WOODROW WILSON BRIDGE REPLACEMENT
RELOCATION OF WOODROW WILSON MEMORIAL MEDALLIONS
City of Alexandria, Virginia and Prince George's County, Maryland

Report to the Federal Highway Administration

April 4, 2002

Abstract

WEST MEMORIAL MEDALLION PYLON AS VIEWED LEAVING VIRGINIA

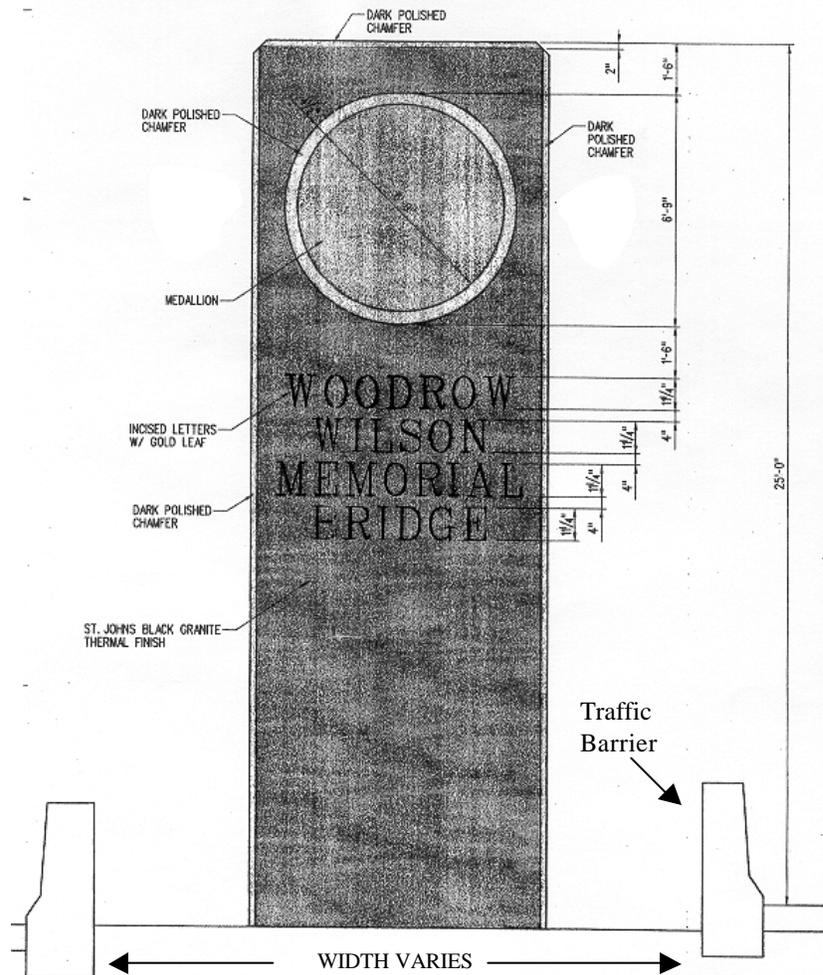
The staff recommends approval of the preliminary and final site development plans for the relocation of the Woodrow Wilson Memorial Medallions. The design successfully balances the bridge's monumental aspirations by incorporating the triangular obelisk-like shape into the vocabulary of the span as a counterpoint. Its classical vertical proportion is highlighted by its clean geometry, which differs with the curving forms of the bridge itself. It is this contrast that makes the presence of the element visible to drivers as they speed by with fleeting glimpses. The stark geometry is also a defining statement from a distance, making it apparent that something different is being called-out at the gateway point where land and bridge meet. The thermal finish will prevent brilliant reflections of vehicle headlights, but because of the large crystal black granite, retains a depth of color providing contrast with the large metal medallion.

FHWA's efforts have resulted in a coordinated physical feature identifying the official title of the bridge itself with the medallion and black pylon design. The plans and construction materials are of the highest quality and the architectural detailing contributes to the monumental character of the final medallion placement.
